REVISION 1 SUPERSEDES REVISION 0

CONTRACT CHANGE ORDER NO. 322 S1
SHEET 2 OF 2

SAN FRANCISCO OAKLAND BAY BRIDGE
EAST SPAN SEISMIC SAFETY PROJECT
SELF-ANCHORED SUSPENSION BRIDGE
(SUPERSTRUCTURE & TOWER)

SKYWAY TRAVELER RAIL REPLACEMENT DETAILS NO. 4

UPPER RAIL SUPPORT DETAILS AT CIP CONCRETE CLOSURE

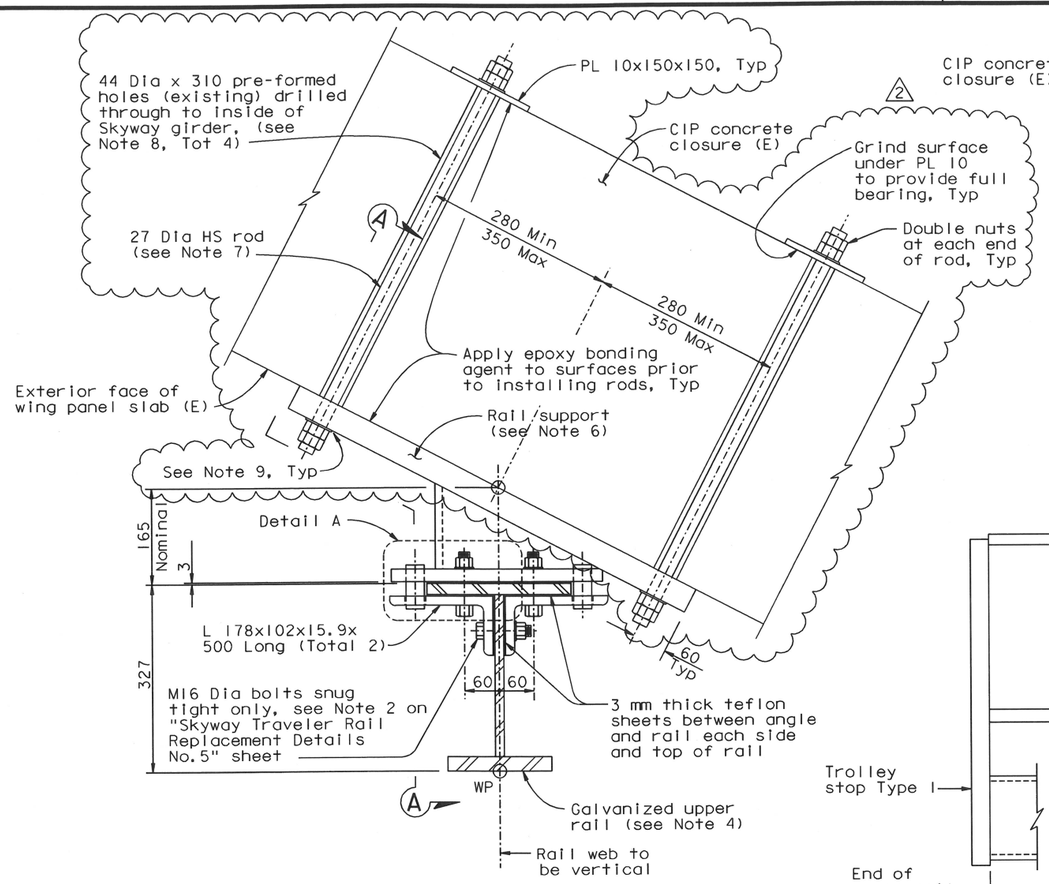
MARK	DATE	DESCRIPTIONS	BY	CH'D	CCO#
2	08/23/13	MODIFY TRVELER RAIL ANCHORAGE	DT	TH	322S1
1	05/18/09	TRAVELER RAIL MODIFICATIONS	TH	RM	24S0
0	07/20/07	RAIL CHANGE AND MISCELLANEOUS DETAILS	TH	RM	24

7. At the Contractor's option, SAE Grade 5 rod may be used. Rod shall be torqued to snug + 1/2 turn.
8. Holes shall be filled with slow-setting methacrylate resin.

9. If 30 Dia hole in PL 44 is slotted or enlarged, use "Detail for Enlarged PL 44 Holes".
10. Hole to be patched per Caltrans Standard Specifications, using pre-approved products.
